# DAUGHTER BOARD

Sheet: /
File: encoder_driver.kicad_sch

A SIDE
DMZ
ATRM1
+3V3
R9
4.7k
R14
100k
+3V3

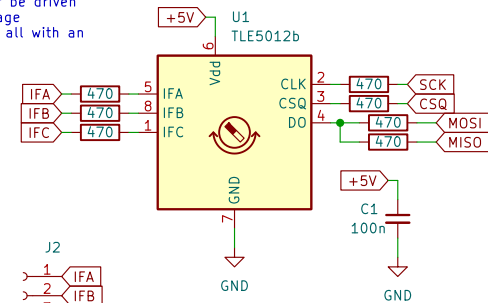
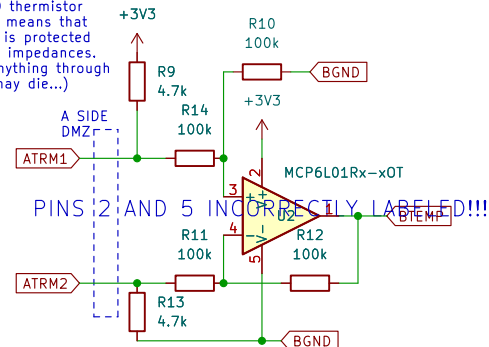
Differential opamp measuring the
voltage across the 10 thermistor
with gain 1 (check...) means that
the rest of the board is protected
by the 100m and 4k7 impedances.
Will be hard to kill anything through
these (the resistors may die...)

PINS 2 AND 5 INCORRECTLY LABELED!!!

IFA,B,C need to go to 3 seperate
isolators, and perhaps leave on
other headers?
